THIRUNINRAVUR TOWN PANCHAYAT
LAYOUT OF HOUSE SITES IN S.Nos:155/6 OF THIRUNINRAVUR VILLAGE.

P.P.D	NO:	13
L.O		2014
APPROVED		
VIDE LETTER NO	:	L1 / 7213 / 2013
DATE	:	25 / 04 / 2014

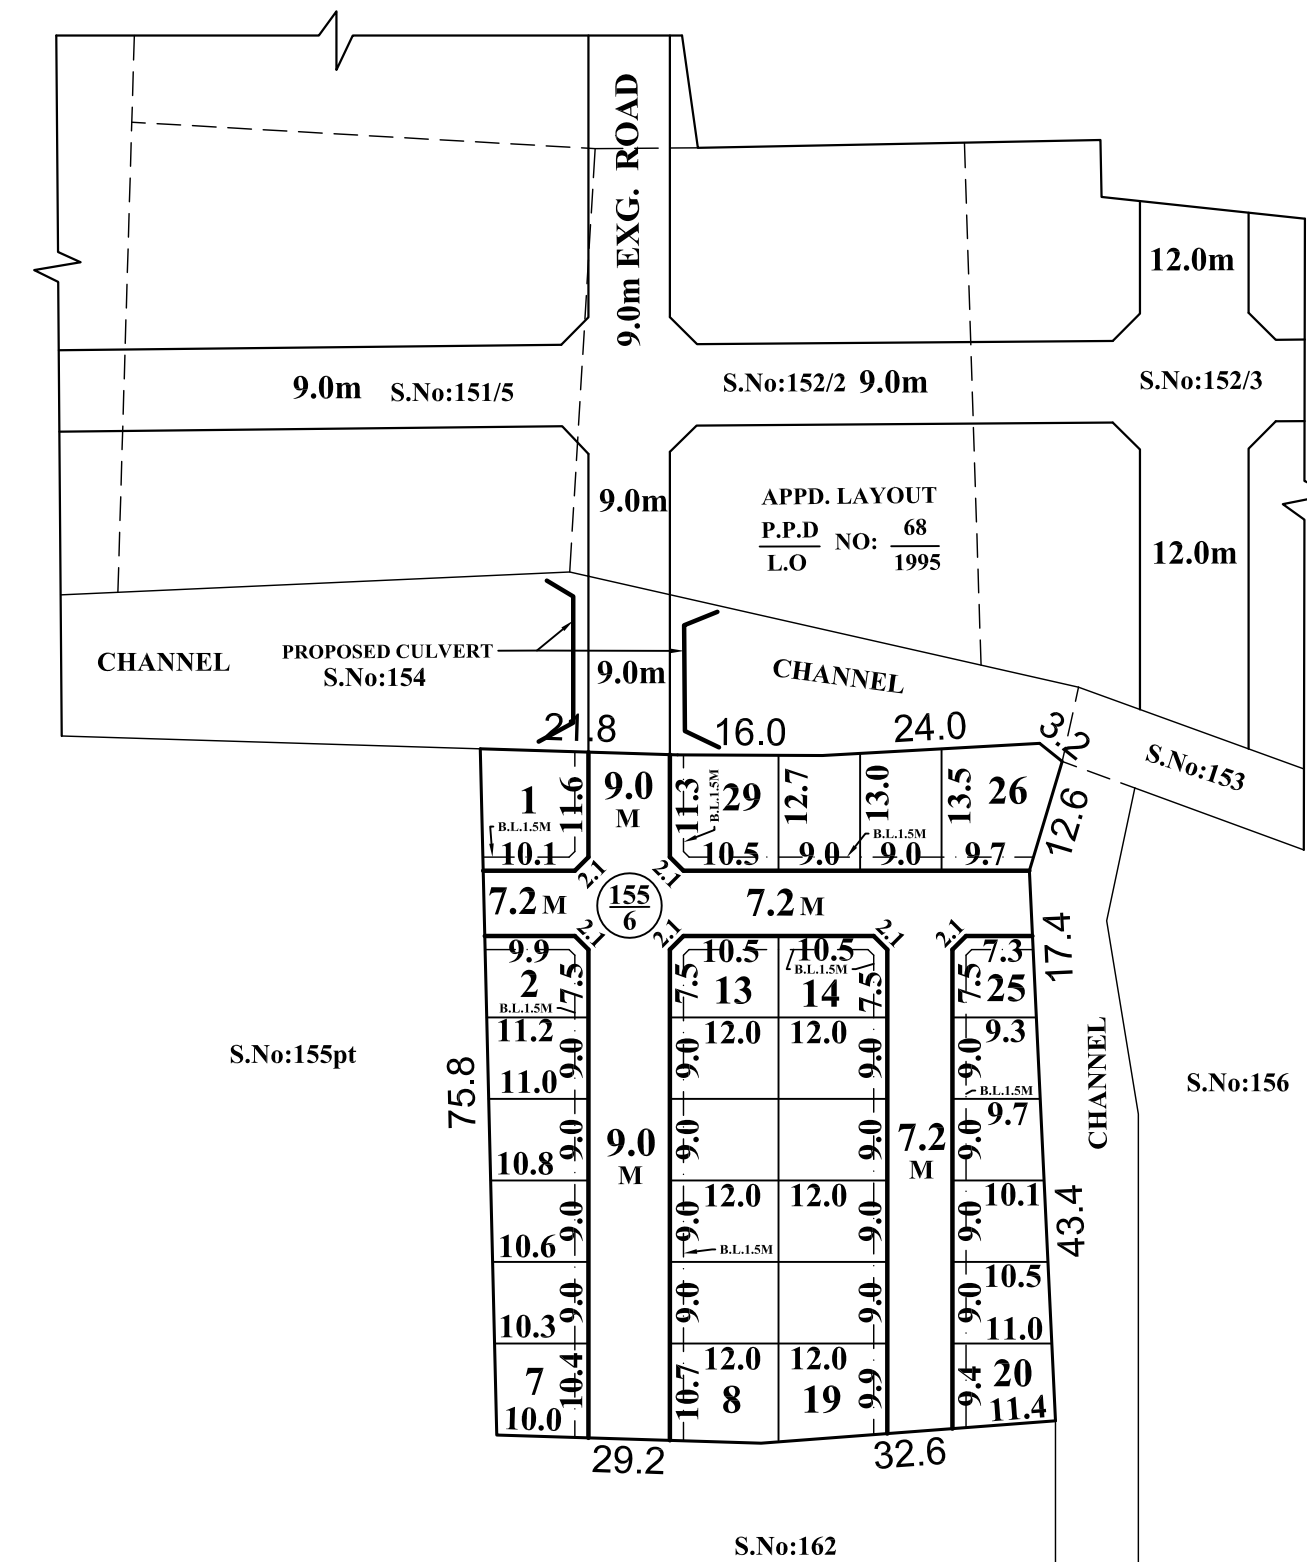
- THE EXISTING GROUND LEVEL OF THE PROPOSED SITE SHOULD BE RAISED TO MINIMUM LEVEL OF (+) 30.530M WITH AN AVERAGE FILLING 1.40M TO AVOID INUNDATION DURING FLOODS AND WATER FLOWING IN THE FIELD CHANNEL AT FSL.

- THE PROCESS OF EARTH FILLING AND COMPACTION SHOULD BE DONE IN LAYERS OF NOT MORE THAN 0.30M DEPTH TO ACHIEVE REQUIRED DEGREE OF COMPACTION.
 - PROPER STORM WATER DRAINAGE CHANNEL NET WORK OF SIZE 600x90 CM SHOULD ALSO BE CONSTRUCTED ALL-ROUND THE PROPOSED SITE BY THE APPLICANTS AT THEIR OWN COST AND THIS DRAINAGE CHANNEL LINKED INTO FIELD CHANNEL FOR DRAIN OUT THE RAIN WATER.

- THE FIELD CHANNEL RUNNING ALONG THE NORTHERN BOUNDARY OF THE APPLICANTS LANDS SHOULD BE MARKED AS PER THE REVENUE RECORDS AND ITS BOUNDARY SHOULD BE CLEARLY DEMARCATED BY LAYING BOUNDARY PILLARS. THE WIDTH OF THE FIELD CHANNEL EARMARKED IN THE REVENUE RECORDS SHOULD BE MAINTAINED WITHOUT ENCRDACHING AS PER REVENUE RECORDS, WITHOUT ANY ENCRDACHMENTS.

- THE PROPOSED CULVERT SHALL BE MADE OF RCC BOX TYPE CULVERT IN SURVEY NUMBER 154 OF THIRUNINRAVUR VILLAGE AND THE RCC BOX TYPE CULVERT WITH NOT MORE THAN TWO VENTS.

- THE PROPOSED RCC BOX TYPE CULVERT SHALL BE CONSTRUCTED ONLY IN SURVEY NUMBER 154 OF THIRUNINRAVUR VILLAGE AS EARMARKED IN THE SKETCH FOR TEMPORARY OCCUPATION FOR THREE YEARS FROM THE DATE OF AGREEMENT.

- THE PROPOSED RCC BOX TYPE CULVERT SHALL BE CONSTRUCTED ONLY CONNECTING IN SURVEY NUMBER 1556 AND EXISTING 30 FEET ROAD OF VASANTHAM NAGAR WHICH IS RUNNING IN BETWEEN SURVEY NUMBER 16 AND 17 OF VASANTHAM NAGAR AS EARMARKED IN THE SKETCH. THE SIZE OF THE PROPOSED RCC BOX TYPE CULVERT IS 10M x [(9.00+8.20)/2M]=9.60M AND FURTHER EXTENSION OF LAYOUT IN ANY OTHER SURVEY NUMBERS SHOULD BE DONE USING THIS RCC BOX TYPE CULVERT WITHOUT THE CONCURRENCE OF THIS DEPARTMENT, SINCE THIS RCC BOX TYPE CULVERT WILL BE A WRD PROPERTY.

- THE SILL LEVEL OF THE PROPOSED RCC BOX TYPE CULVERT & BOTTOM LEVEL OF DECK SLAB SHOULD BE FIXED IN THE PRESENCE OF WRD OFFICIALS.
- THE DESIGN & DRAWINGS OF THE ABOVE RCC BOX TYPE CULVERT SHOULD BE COMMUNICATED TO THE EXECUTIVE ENGINEER, WRD, KOSASTHALAIYAR BASIN DIVISION, THIRUVALLUR FOR APPROVAL AND THE WORK SCHEDULE SHOULD ALSO BE INFORMED TO HIM FOR MONITORING PRIOR TO COMMENCEMENT OF THE WORK.
